Final Environmental Impact Statement

**Ox Mountain Sanitary Landfill
Apanolio Canyon Expansion Site
San Mateo County, California**

Volume I - Final EIS and Response to Comments

**US Army Corps
of Engineers**
San Francisco District

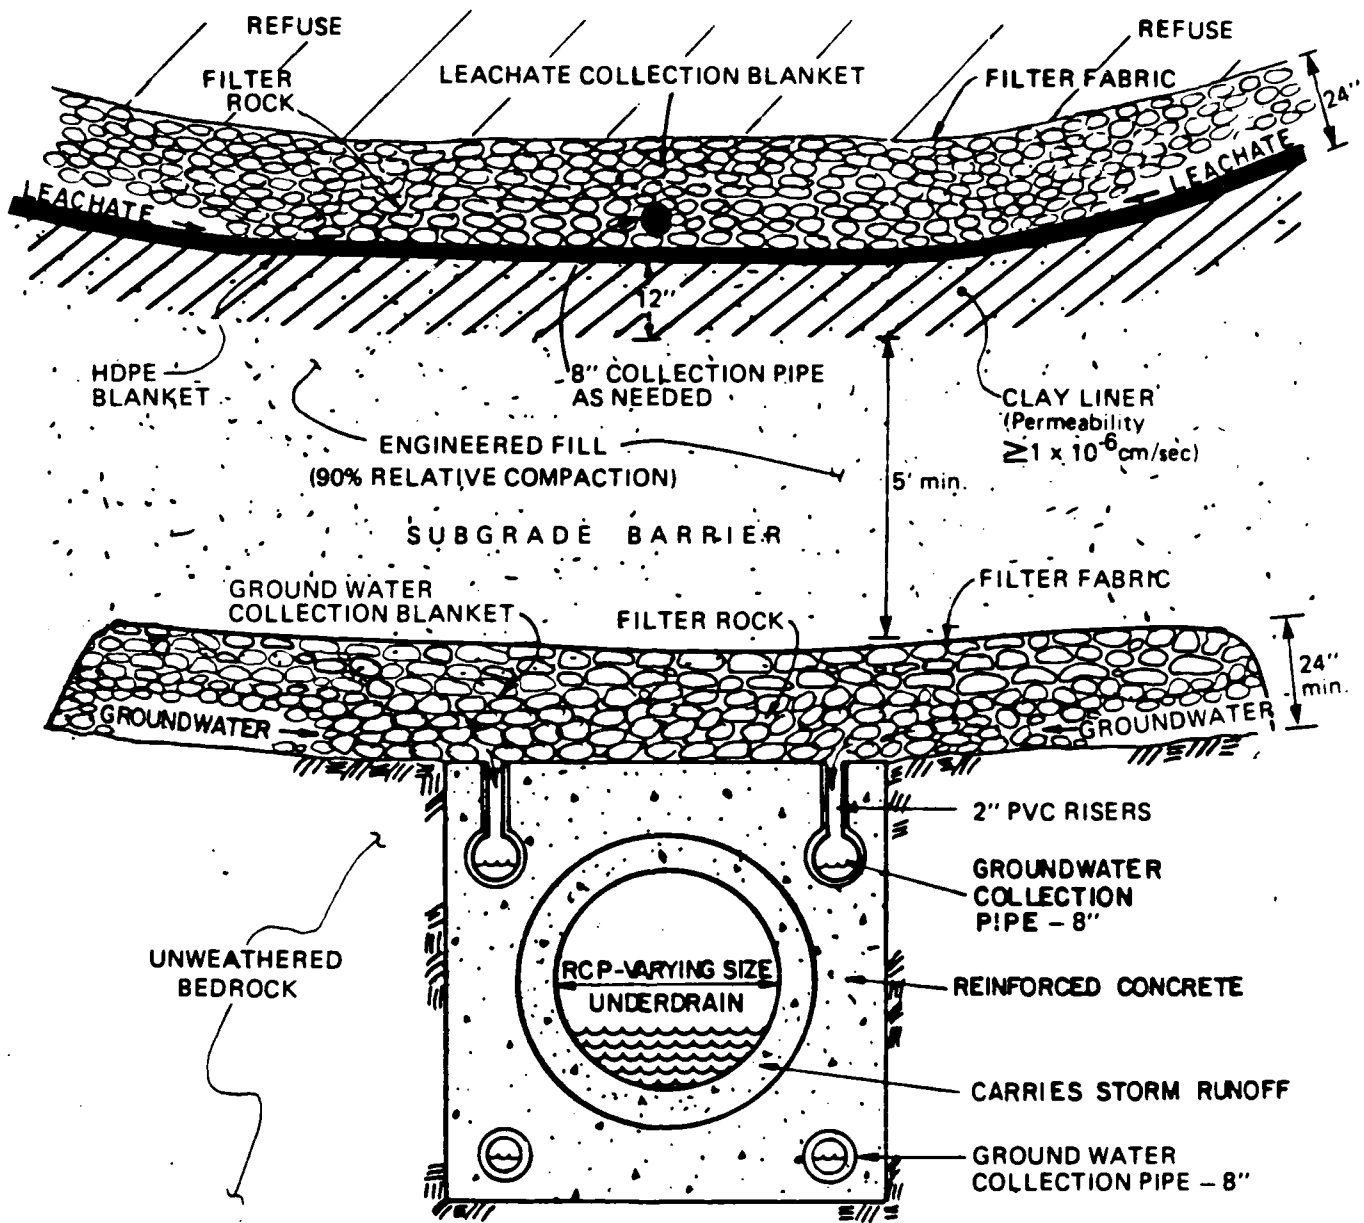
Given the approximate 1,000 foot separation between the drains (pages 3-32 to 3-35, Figure 3.5-6), the draft EIS should provide the calculated groundwater elevations at mid-points between the drains as part of the environmental assessment. Without such data, the efficiency of the groundwater collection system cannot be assessed and environmental impacts cannot be evaluated. In addition, a scale should be provided for the drainage system drawing (see Figure 3.5-8).

5-40. The storm-water underdrain system would be installed in each tributary side-canyon watershed that drains directly into the main Apanolio Canyon Creek. The storm-water underdrains, as shown on figure 3.5-6 of the EIS, would be located in each identifiable watershed within the canyon. Detailed information on the underdrain system is described in Hydrocomp, January 1988.

3.5-7

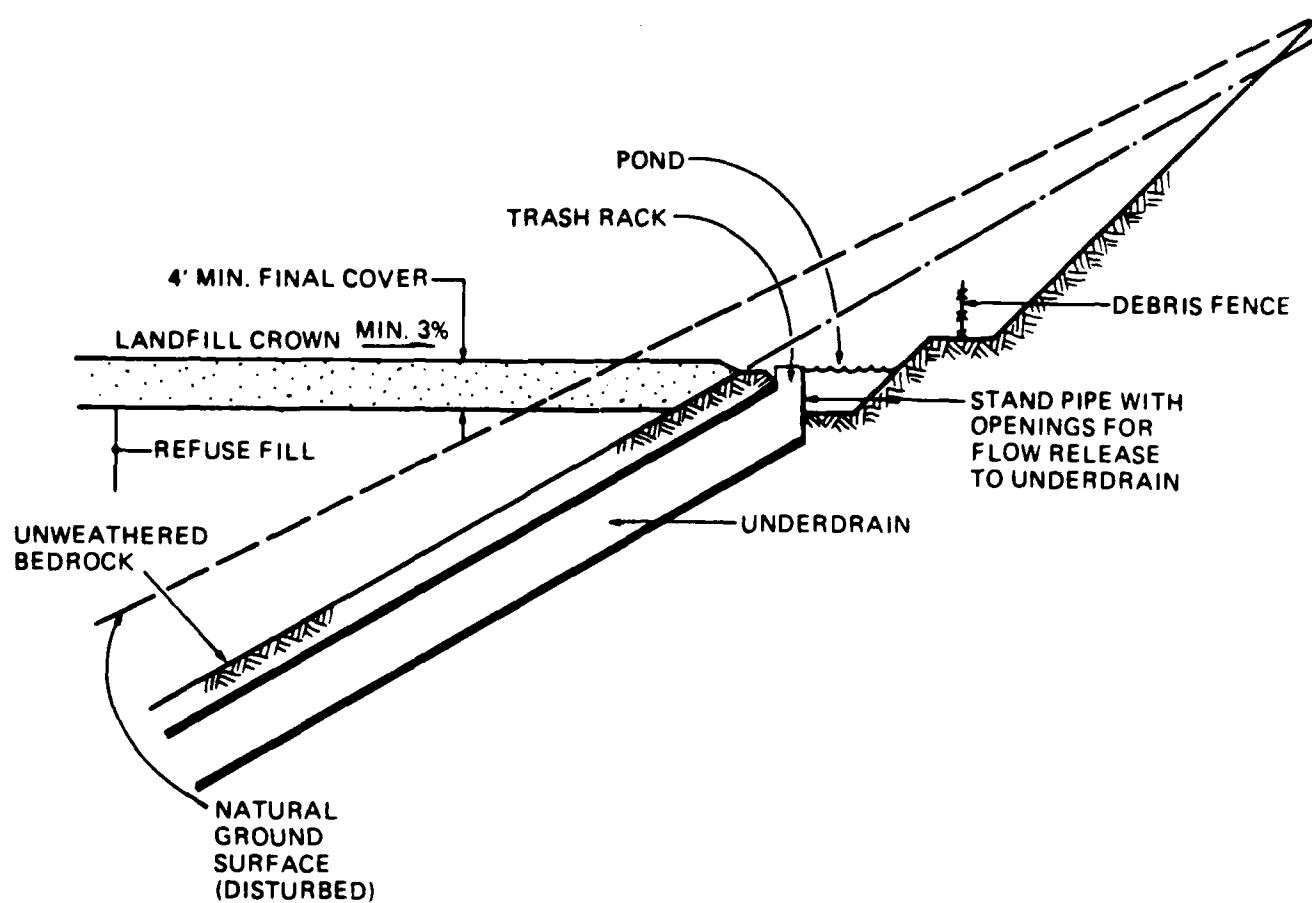
The design of the clay liner and leachate collection blanket, as shown in Figure 3-4-7 (page 3-36), does not appear to be appropriate given the high angles of the natural slopes. It would be very difficult, if not impossible, to install a 12-inch clay liner on a 2:1, or even up to a 1:1, slope in the canyon area. The revised draft EIS should substantiate any claims as to the constructibility of this liner and EIS should describe system, and anticipated construction and quality control problems.

8. Page 3-39. The description of the collection system for the use of filter fabric surrounding the filter rock overlying the bedrock is not shown in Figure 3-5-7 as stated. Revise the figure to include the filter fabric.

33-8. See revised EIS Figure 3.5-7, which shows filter fabric for the ground-water collection system.

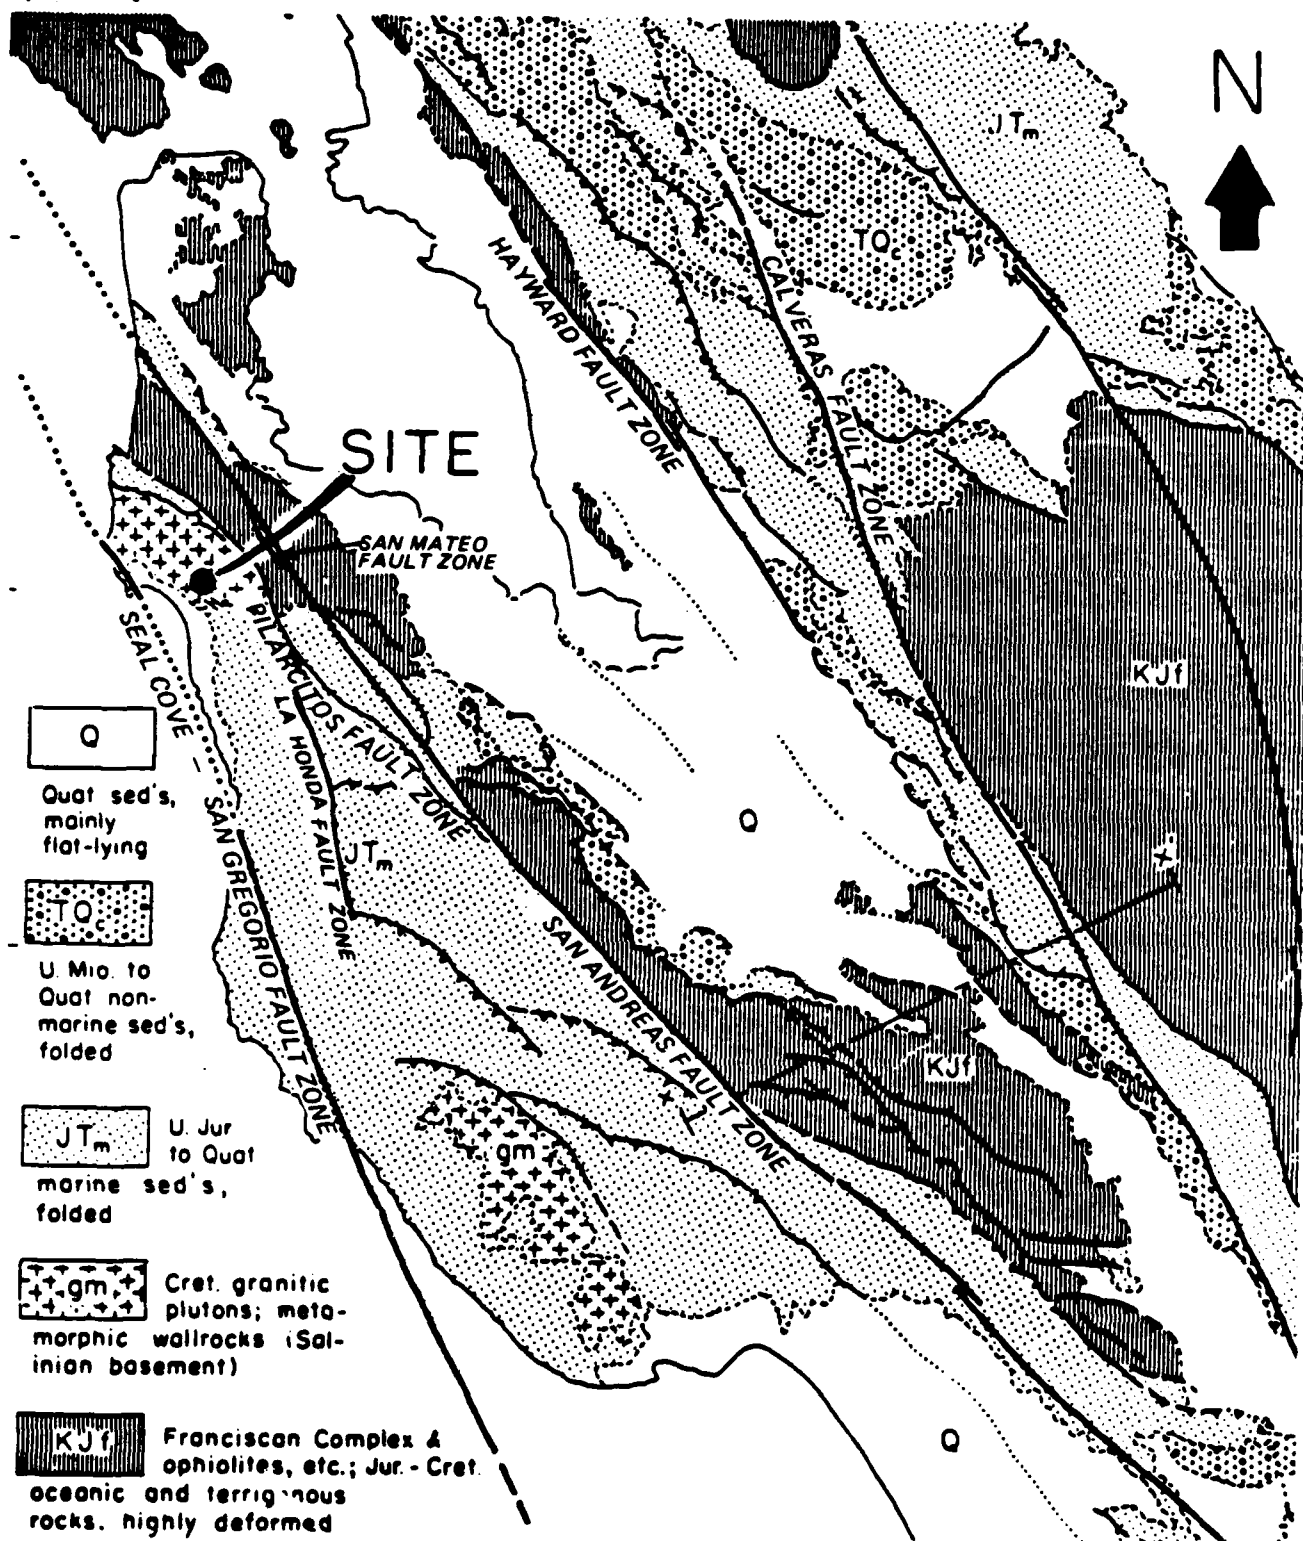
Potentially active faults are listed as the Pilarcitos, San Mateo, and La Honda faults. It is stated in the draft EIS (page 4-3) that the potential for severe ground shaking from potentially active faults at Apanollo Canyon is less than for the recognized active faults. However, no justification for this determination is provided. The San Mateo and La Honda faults are not indicated on a location map (e.g., Figure 4.1-1).

5-55. Justification is based on USGS and CDMG published data used by others in the profession. Basis for this justification would include: 1) Activity level of the faults (Pilarcitos, San Mateo, and La Honda faults are not considered active, whereas the San Andreas, Hayward and Calaveras faults are classified active - last 10,000 years - and have also been active historically - last 200 years -); 2) length of fault; and 3) recurrence interval. Figure 4.1-1 has been revised to indicate the location of the San Mateo and La Honda faults.

4.1-3

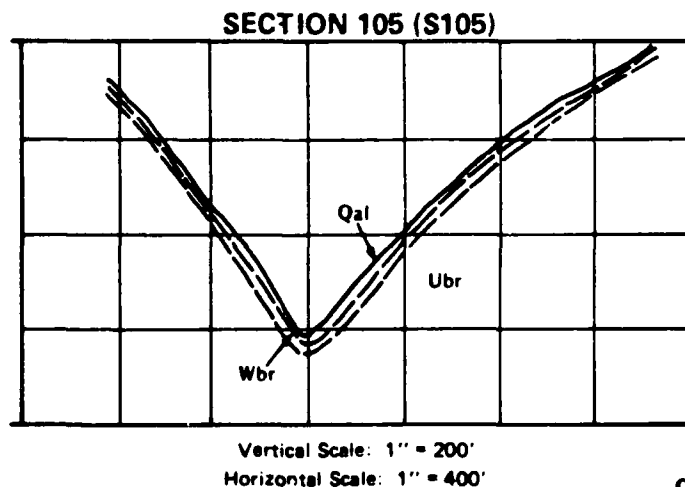
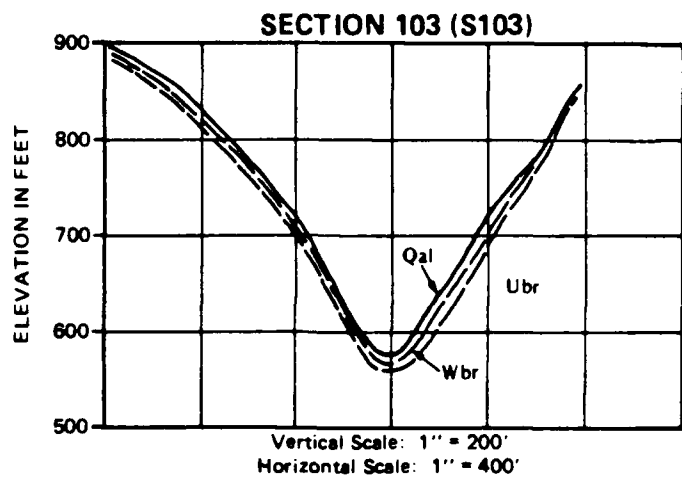
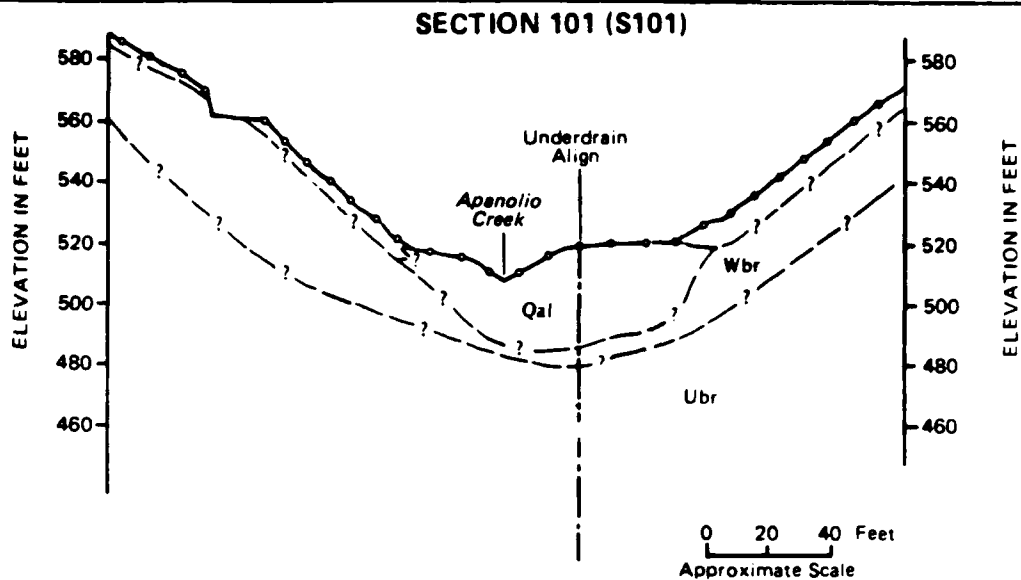
The geological cross sections discussed in Section 4.1(b) are not described adequately (see page 4-7, paragraph 3). Were the cross sections generated from actual borings? If so, the locations of the borings should be depicted in Figure 4.1-3 along the cross section. Section 101 of Figure 4.1-4 (page 4-9) shows weathered and unweathered bedrock, as well as the recent alluvium/colluvium, with dashed lines. If these cross sections were generated from borings, why are they shown as dashed lines? The revised draft EIS should present specific locations for borings on the slopes of the canyon, as well as elevations of weathered and unweathered bedrock and groundwater levels.

5-32. The geologic cross sections illustrated in Figure 4.1-4 were constructed using data obtained from geologic surface mapping, and monitoring well and geologic boring data generated during geotechnical investigation of the canyon. Figure 4.1-3 (Revised) of the EIS shows the location of borings made within Apanolio Canyon. Appendix D contains summary data on locations and elevations of borings. The cross sections presented in Figure 4.1-4 show geologic contact lines, dashed where approximate and question marked where uncertain which is a standard in the profession.
